GOVERNMENT OF THE DISTRICT OF COLUMBIA
DEPARTMENT OF TRANSPORTATION

MEMORANDUM

SUBJECT: **ZC Case No. 15-10** – Deanwood Hills – 5201 Hayes Street, NE

Figure 1: Site Design and Access (Source: Grove/Slade Associates)

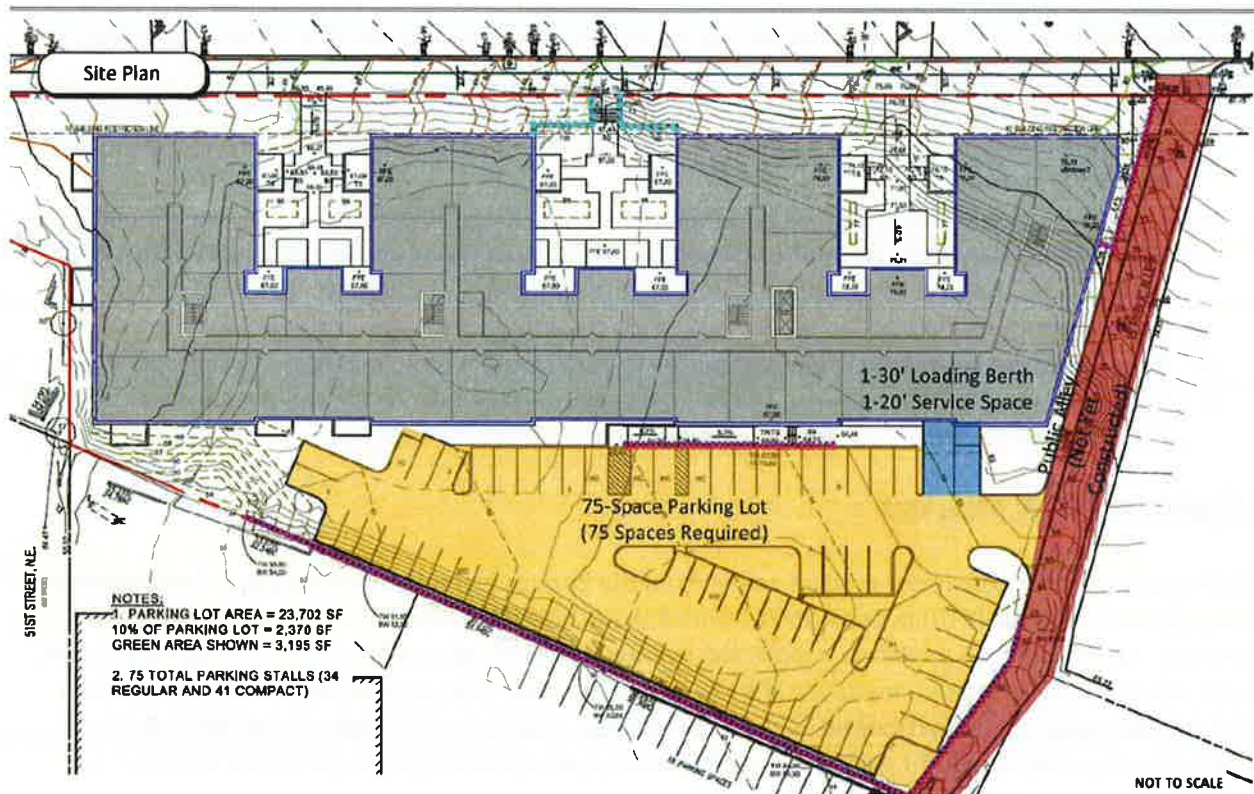
The Applicant proposes all vehicular, including truck, access to the site through a north-south public alley to the east of the site. The Applicant proposes to build out the unimproved public alley adjacent to their site in order to connect Hayes Street with an existing public alley that runs north-south from Nannie Helen Burroughs Avenue. This alley extension will be widened five feet onto private property by an easement and will be 20 feet wide. The Applicant is expected to build the public alley to current

Loading will be accessed through the proposed public alley extension. No back-up maneuvers will occur in the public realm. DDOT believes that it may be difficult for 40 foot garbage trucks to turn from the alley into the site. The Applicant has assured DDOT that 30 foot garbage trucks will be used. As truck turning diagrams for the 40 foot trucks have not been provided to DDOT, DDOT cannot assess impacts.

In the event that 40 foot garbage trucks need to utilize the site, the Applicant will need to adjust the curb radius into the surface parking from the alley. The curb radius will be addressed during the public space permitting process.

DDOT standards and apply for the appropriate public space permits.
